PROJECT REVIEW REPORT

Project ID	1721
Project Name	ONIL Stoves –Guatemala – Uspantán
Program(s)	VCS
Verification Period	01 August 2018 – 31 August 2020
Project Proponent	1) HELPS International Incorporated 2) C-Quest Capital LLC
Methodology	Registered under AMS-II.G., proposing to change to VMR0006
Sectoral Scope(s)	3 – Energy demand
Validation/Verification Body (VVB)	Earthood Services Private Limited
Assessment Criteria	VCS Standard, v4.1
Date of First Issue	16 July 2021
Date of Final Issue	3 September 2021

Compiled from UNdata | record view | Fuelwood

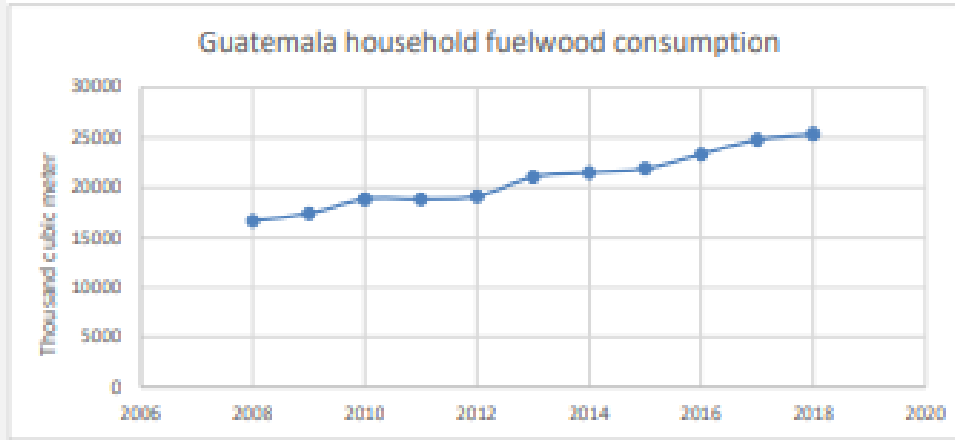
In reality, the fuelwood consumption in Guatemala has been increasing steadily at an average rate of 4.3% in the past 10 years. The high consumption values stem from the fact that a considerable percentage of rural population in Guatemala depend on wood fuel for meeting their cooking needs. The number stood at a high of 83% according to the last DHS conducted in the year 2014-15.
